SERVICE INFORMATION BULLETIN

NUMBER: 07-133-18R

SUBJECT: Knock Sensor Design Change, DTCs P0327, P0328, P0332 and P0333

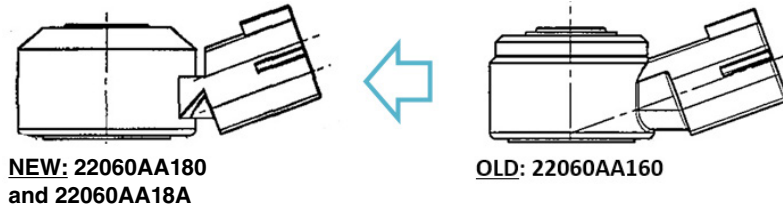
- The part number for the new knock sensor to be used on Japan-built vehicles is: **22060AA180**.
- The part number for the new knock sensor to be used on SIA / US-built vehicles is: **22060AA18A**.

The reference illustrations below show the difference between the new and the old part.
